# UNITED STATES PATENT AND TRADEMARK OFFICE

## Office Action Summary

10/632,273

FARNWORTH ET AL.

Selected Portion of Figure 4

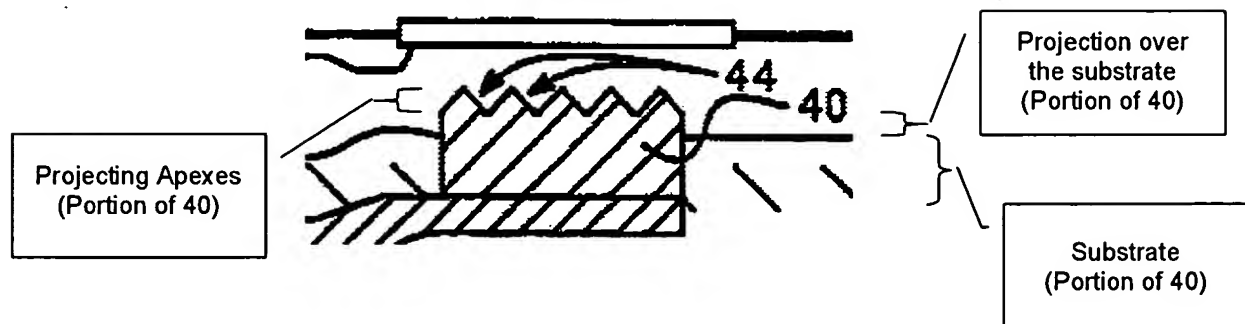
Agahdel et al anticipates (Figure 4) an engagement probe (40) comprising:

A substrate (that portion of 40 as labeled below);

A projection supported over the substrate (that portion of 40 as labeled below) and comprising material of the substrate; and

A grouping of a plurality of projecting apexes (that portion of 40 as labeled below) extending from the projection and positioned in sufficient proximity to one another to collectively engage a single conductive pad (45) on a semiconductor substrate (22); as recited in claim 31.

As to claim 33 the added limitation of the apices being in the shape of multiple knife-edge lines is anticipated (because Figure 4 is a cross-sectional view of Figure 3 along line 4--4, the "Projecting Apexes" are part of a 3-dimensional object having each cross-sectional component, or slice, as a "Projecting Apex." Thus the tips of all the slices in combination form a knife-edge line; see also col 6, ln 16-29).

As to claim 45, the added limitation of the plurality of projecting apexes extending from a substantially planar uppermost surface (note base of Projecting Apexes are linear to each other and therefore form a plane along line 4--4 of Figure 3) of the projection is anticipated.
